| JRPP Ref. No. | 2012SYE002 |
| D/A No. | DA-592/2011 |
| Proposal | Construction of a residential flat building containing 254 dwellings and three levels of basement parking |
| Report By | Bernard Sutton – Development Assessment Officer |

Figure 3. Extract of Height Maps from CLEP 138

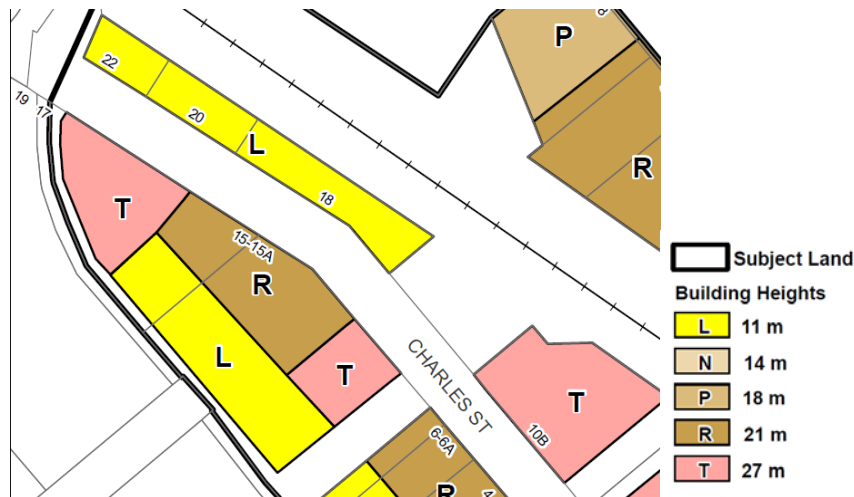
The proposal generally conforms with the height requirements of CLEP 138, with the exception of the area identified as “T” 27 metres. The proposal exceeds the height by up to 1.6 metres for lift over runs and parapet design.

CLEP 138 does not define where the height is measured to. However, given that the definition of height within the Standard Instrument includes the total height of any building, including roof pitch, lift over runs and the like, the applicant has submitted an objection to this development standard under State Environmental Planning Policy No.1 – Development Standards.

Fig 5. Building Height Plan of DCP 55

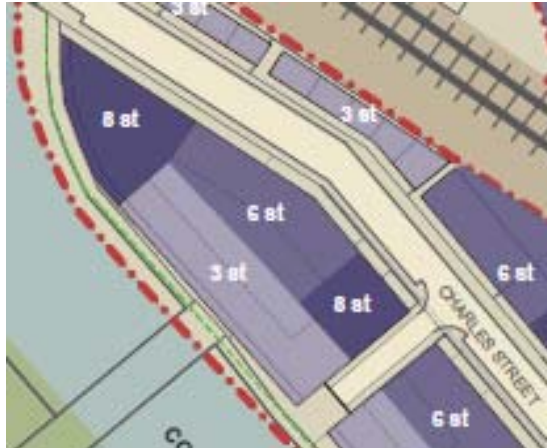
The proposed development complies with the 3 storey height limit along the Cooks River. However, the proposal is seeking a variation to the 6 and 8 storey components of the plan.
